MFN 08-930

**Subject: Response to Portion of NRC Request for Additional Information Letter Nos. 170 and 245 Related to ESBWR Design Certification Application - Containment Systems - RAI Numbers 6.2-173 S01 and 6.2-196**

**Response to Portion of NRC Request for  
Additional Information Letter Nos. 170 and 245  
Related to ESBWR Design Certification Application**

**RAI Numbers 6.2-173 S01 and 6.2-196**

**Figure 3.K.1. RPV Water Level: 30 Days Post-LOCA Response  
– First 2000 Seconds**

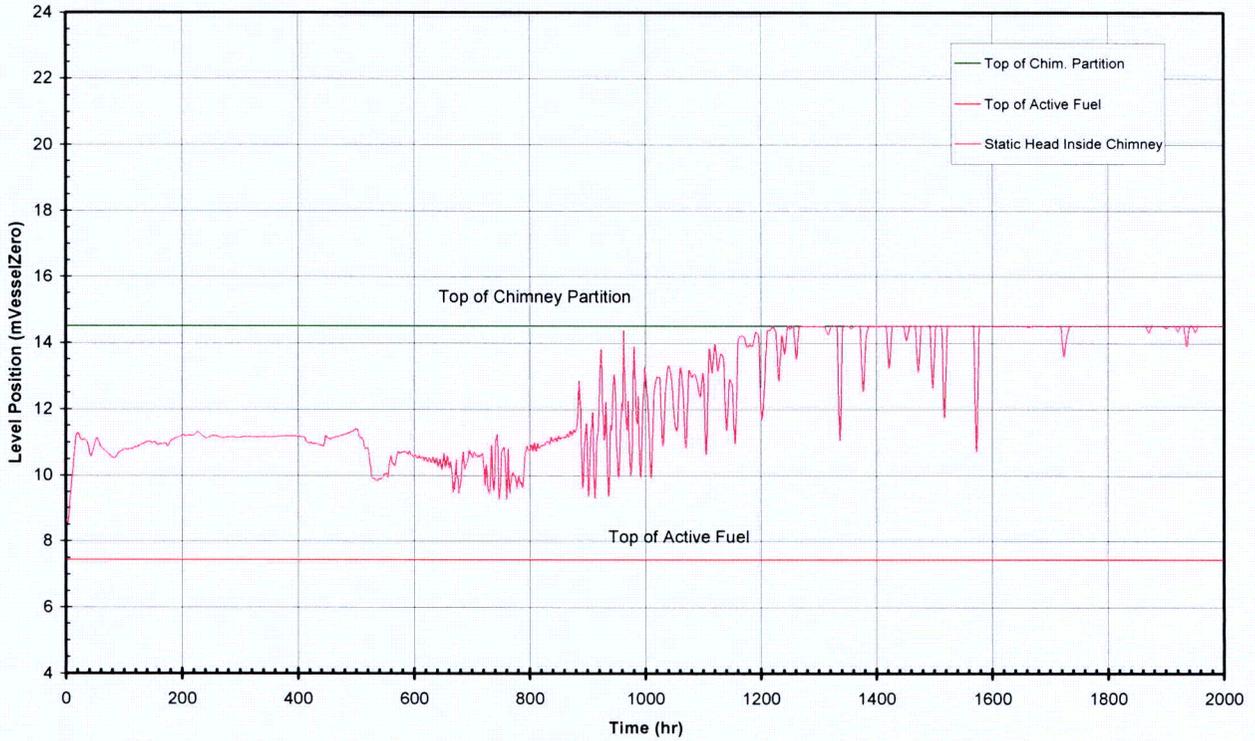
- J. *Show how the NPSH changes as a function of time during the operation of suppression pool cooling and low pressure core cooling systems.*
- K. *Please (i) confirm that the equalization line is equipped with a stack disc debris strainer that is designed in accordance with Regulatory Guide 1.82, revision 3, or (ii) provide a plot of the calculation results showing RPV water level has stabilized 30 days without the need for the GDCS equalization line.*

- K. Response to RAI 6.2-140 S02 presents 30 days post-LOCA results for containment pressure and temperature. RPV water level for that same scenario is shown in Figures 3.K.1 and 3.K.2. Water level is stabilized after 30 minutes and remains above the top of chimney partition, therefore the GDCS equalizing lines are not used to provide makeup. PCCS remains in operation and provides condensate to the RPV through the GDCS pool injection lines. Therefore, a strainer will not be used on the GDCS equalizing lines. Instead, screens will be utilized as previously discussed. There are total of four equalizing lines.

**Figure 3.J.1. Typical GE BWR Passive Strainer Design**

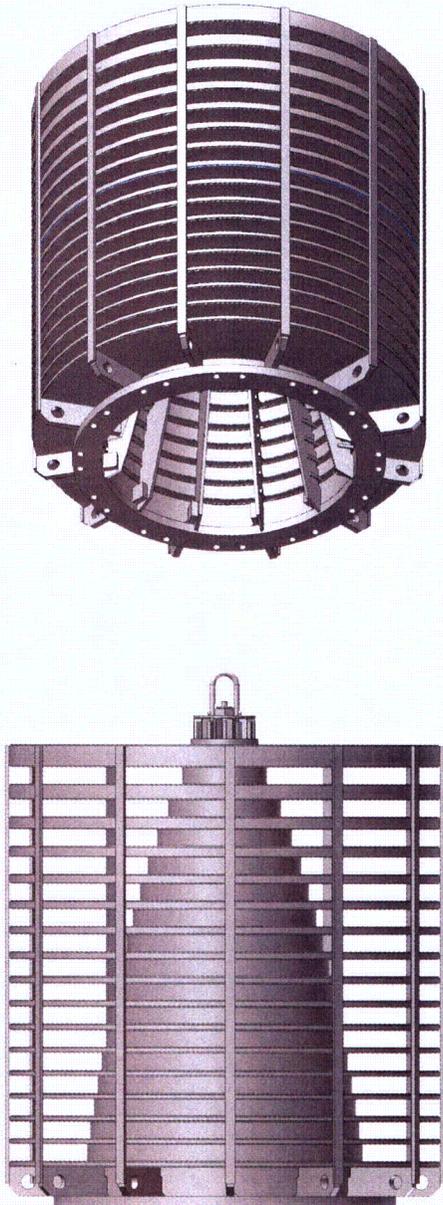
- M. *Discuss how the suction strainer geometry and surface area are designed to handle suppression pool debris material loads with acceptable strainer head losses.*

The debris head loss was calculated for a prototypical Boiling Water Reactor (BWR) stacked disc design as shown in Figure 3.J.1 with a 45 inch OD, a 49 inch hydraulic length, and a 388 ft<sup>2</sup> surface area. The amounts and types of debris used to calculate the debris head loss are shown in Table 3.J.2. Even though fibrous debris is not allowed in the ESWR containment design, head loss is analyzed with fibrous debris to show the robustness of the suppression pool cooling function. The surface area for RMI transported to the suppression pool is not used in calculating debris head loss. Instead, the saturated condition of RMI is used and is predicted at 1200 ft<sup>2</sup> RMI surface area, which is about a third of the predicted amount transported to the suppression pool, Table 3.C.2.

- M. The suppression pool strainer for the FAPCS will be of a stacked disc design. Figure 3.J.1 shows a prototypical BWR stacked disc design. These types of strainers have been designed and tested to withstand anticipated debris and other structural loads while maintaining acceptable head losses.
